Update to Bid Documents – May 20, 2025

VAMC St. Cloud, MN
Remodel Building 51-1 Eastside
4801 Veterans Drive
St. Cloud, MN 56303

VA Project 656-19-307
May 20, 2025
Update to Bid Documents

1 BUILDING 48 - FIRST FLOOR - ICRA, CONSTRUCTION BARRIER & PHASING PLAN
3/32" = 1'-0"

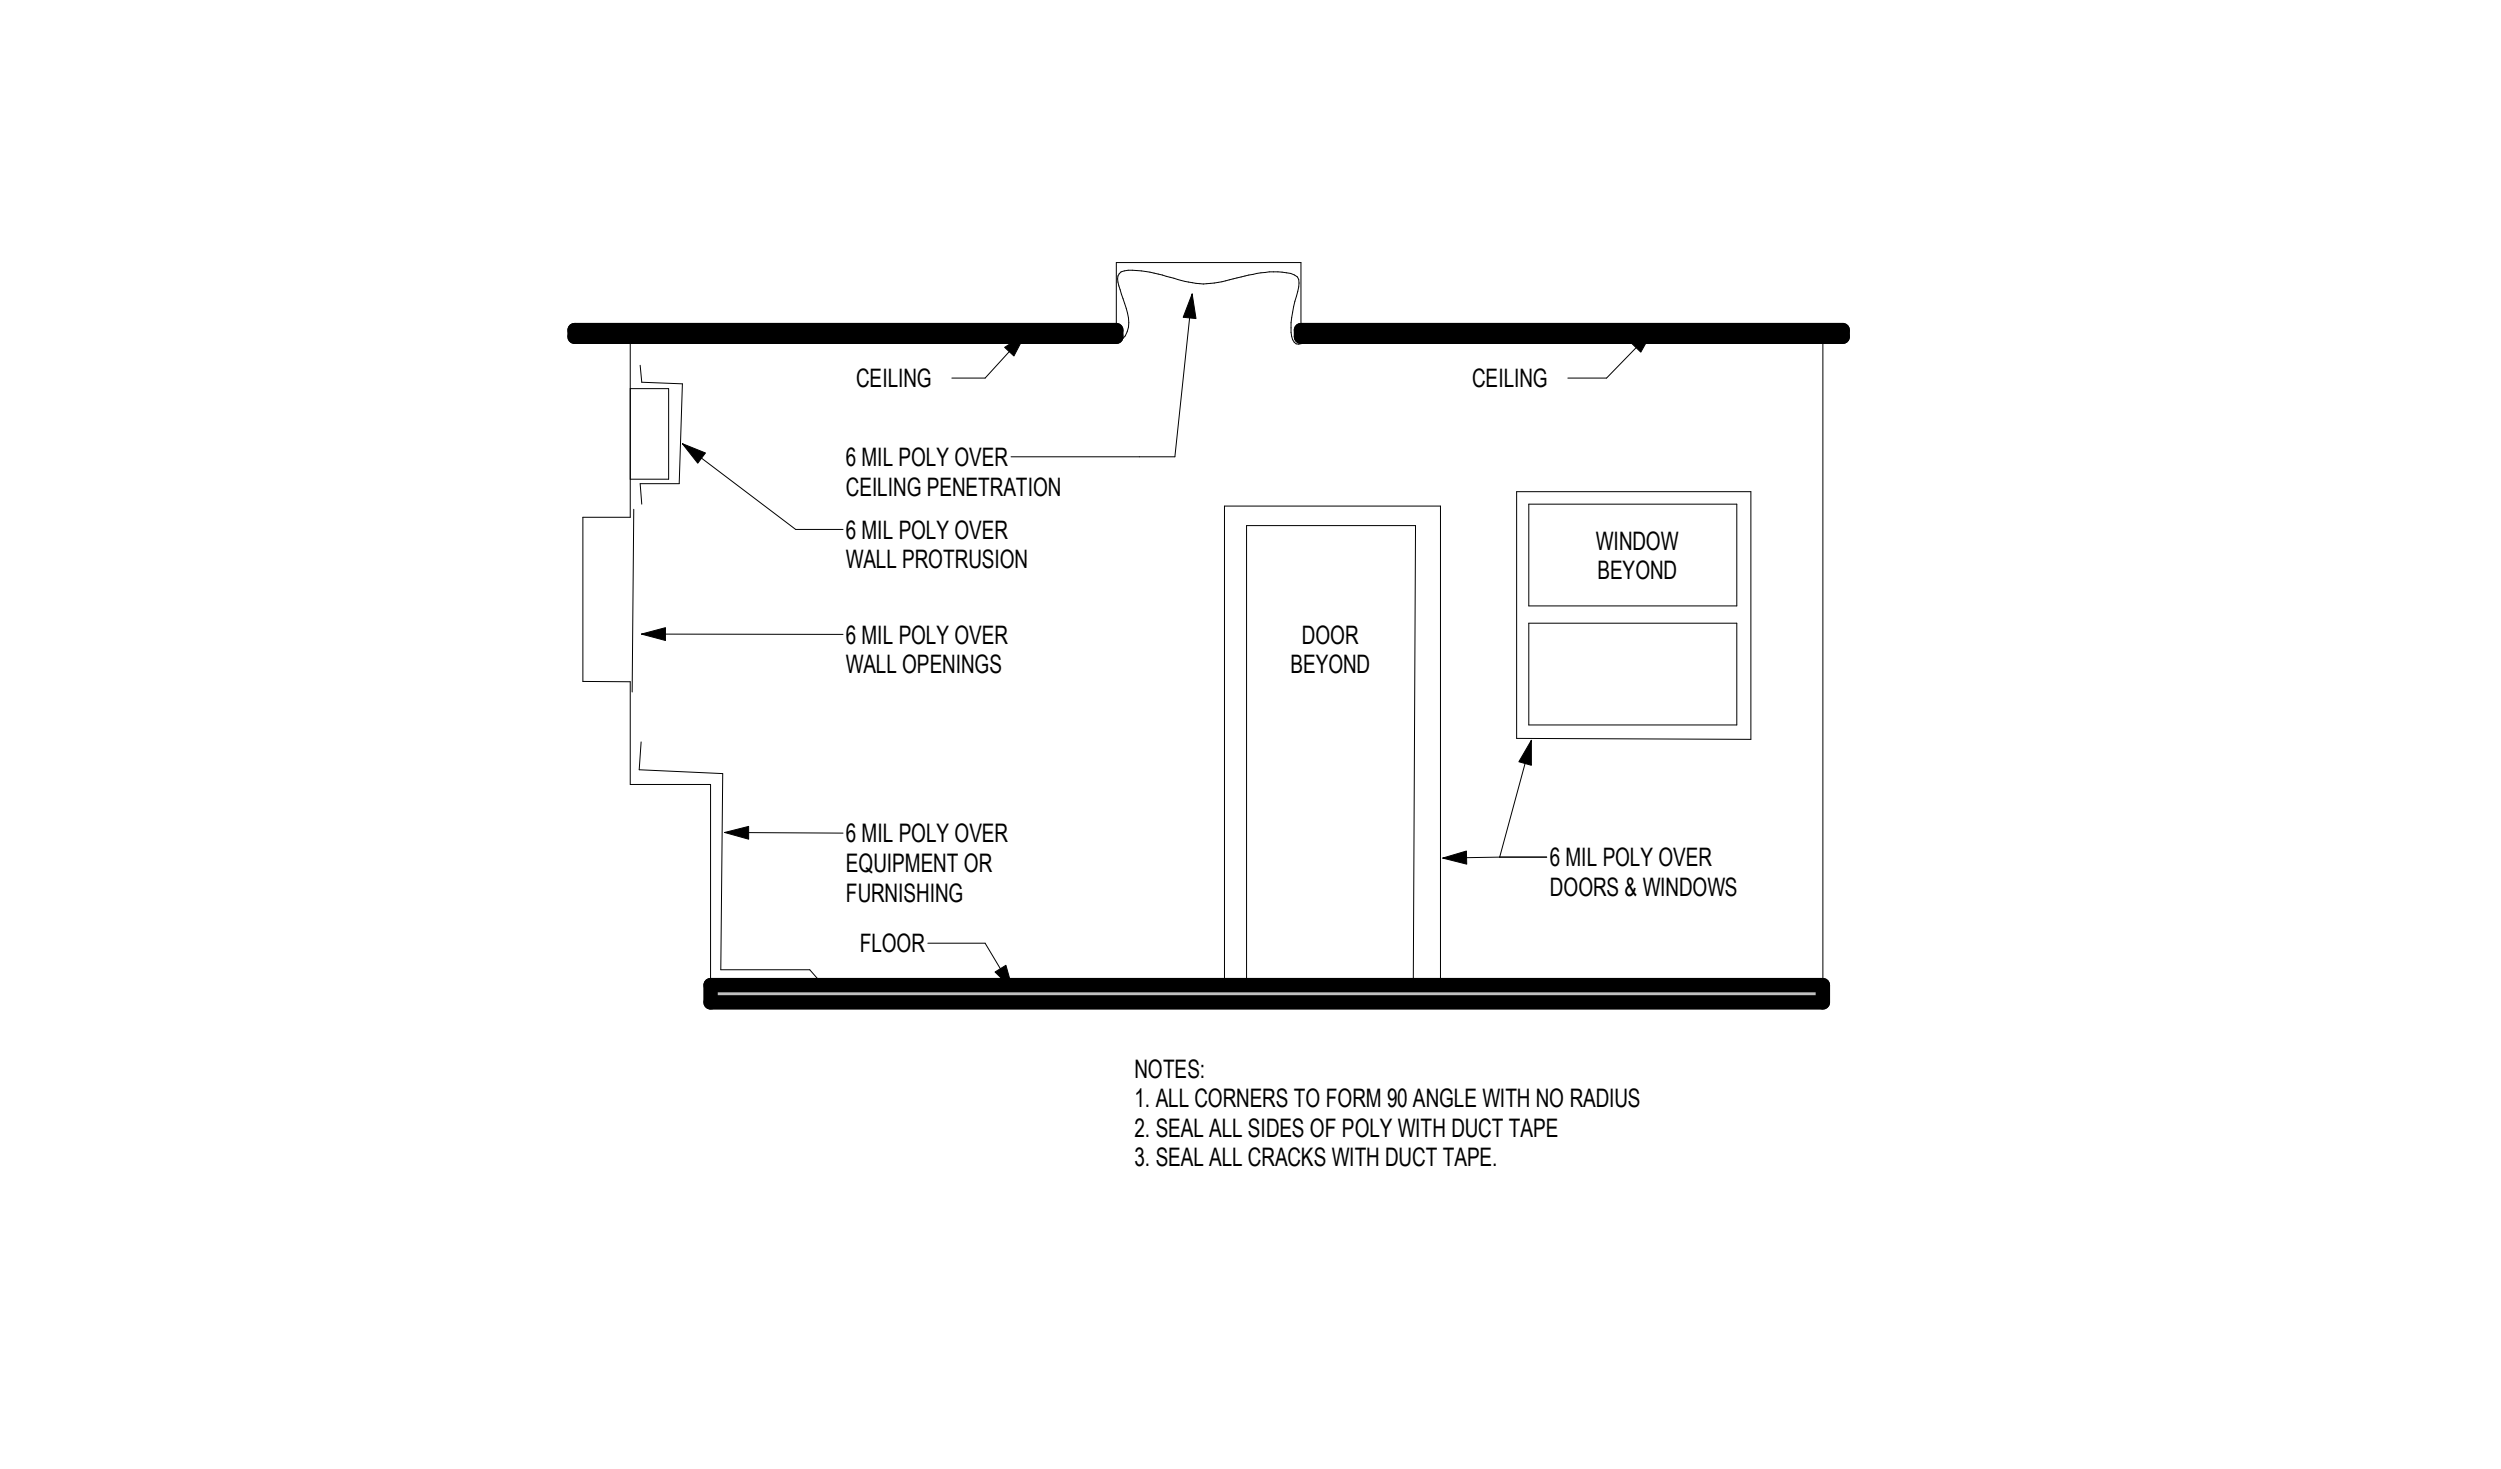
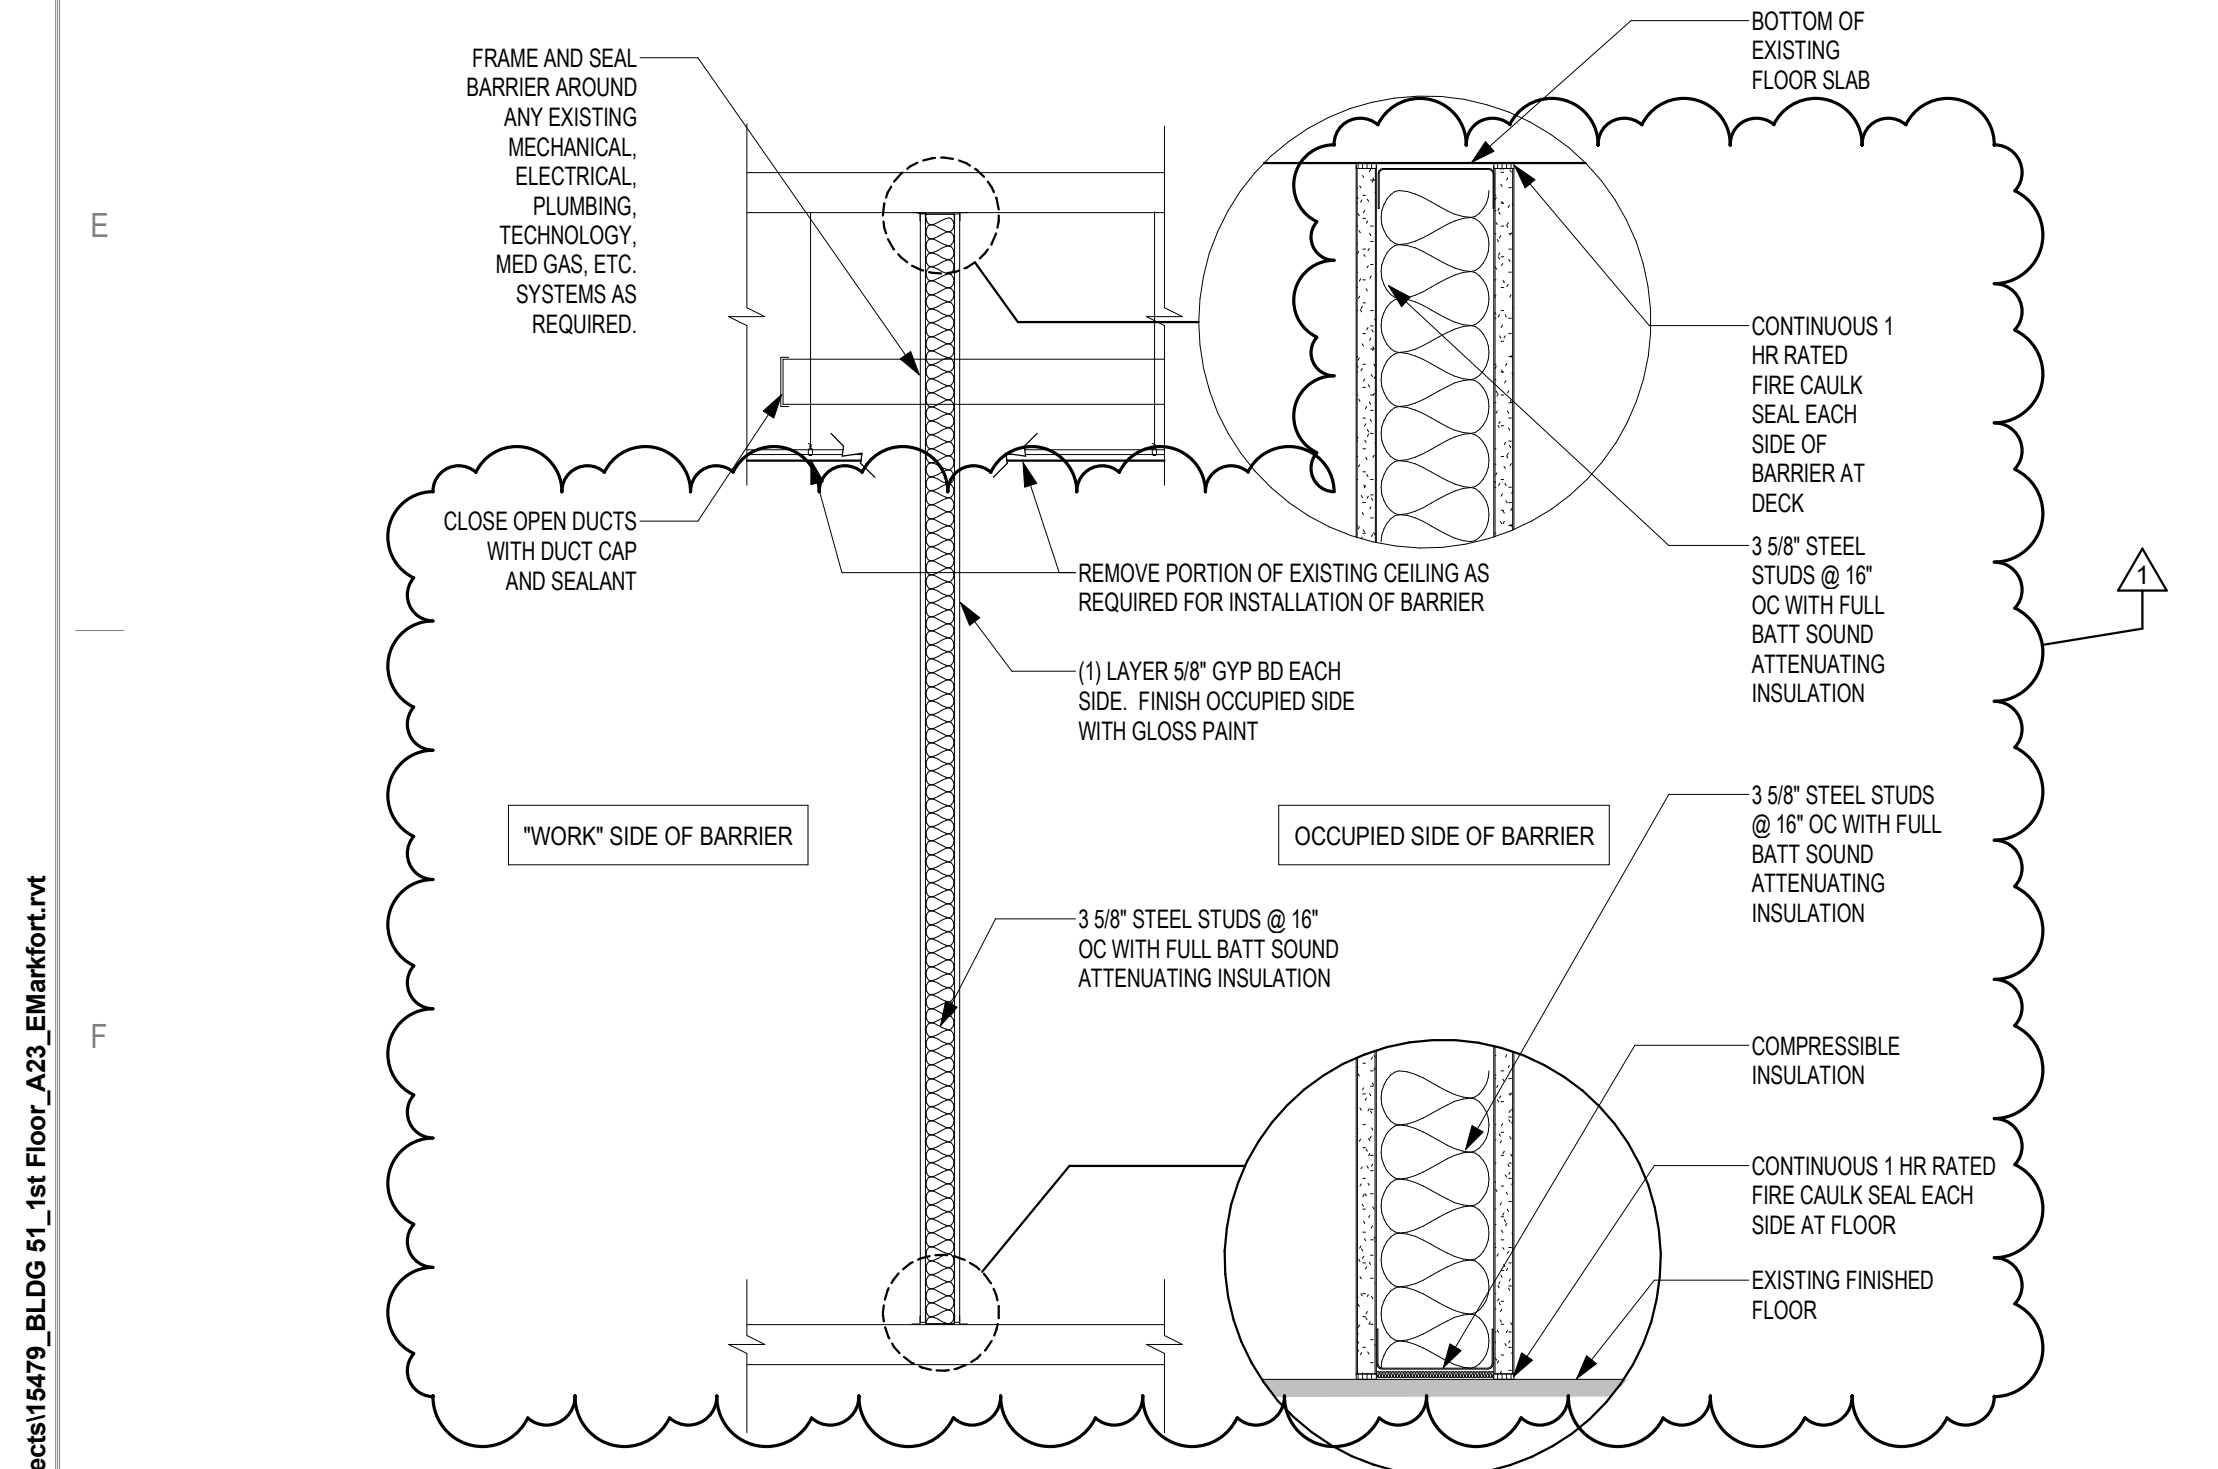
5. Sheet GI001
 - a. Update to sheet index
6. Sheet GC110
 - a. Update room 106B
 - b. REVISE Detail 4
7. Sheet GC500
 - a. REVISE ideal plan – remove supply and return and cap at main duct.

1 FIRST FLOOR DEMOLITION PLAN
1/8" = 1'-0"

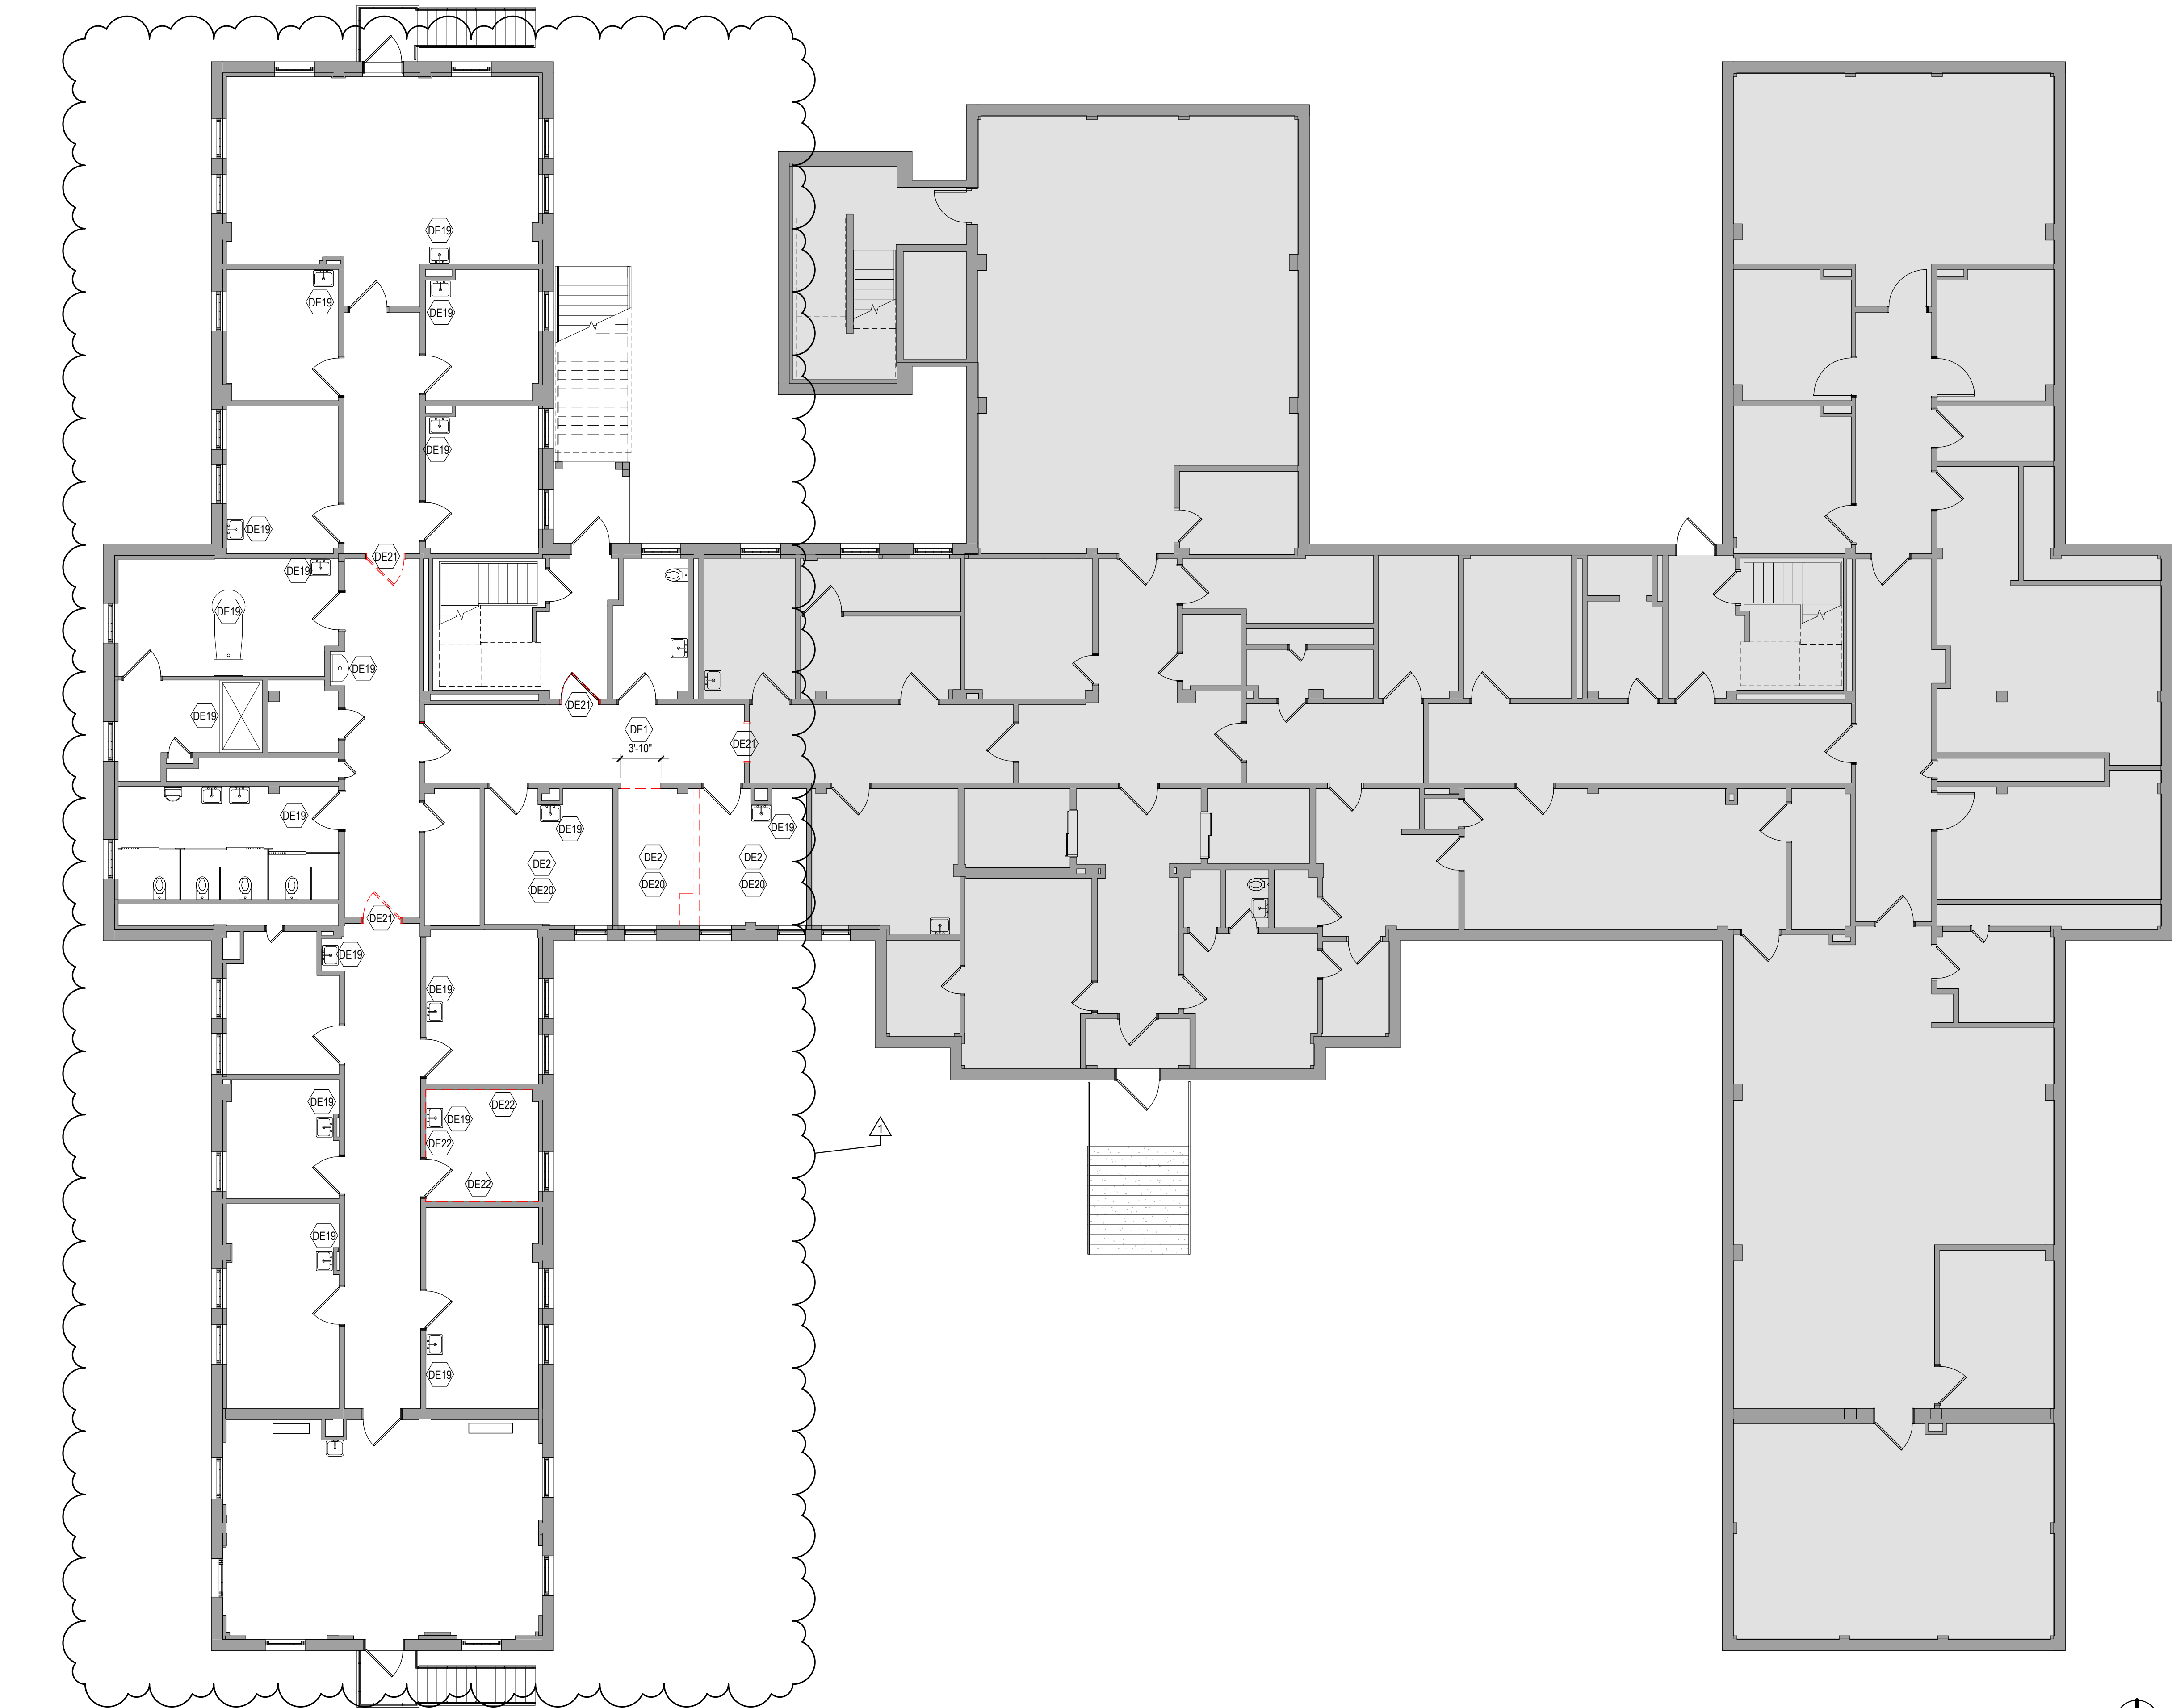
8. Sheet 48-AD111
 - a. OMIT keyed notes 20 and 22 at rooms. Keyed note 20 to remain at Rooms 103 and 104. Keyed note 22 to apply at room 106B.
 - b. REVISE keyed note 20

- c. REVISE keyed note 22
 - d. REVISE keyed note 23
 - e. REVISE keyed note 24
9. Sheet 51-AD111
 - a. REVISE drawing 1 - keyed note 20 shall apply to all spaces not hatched.
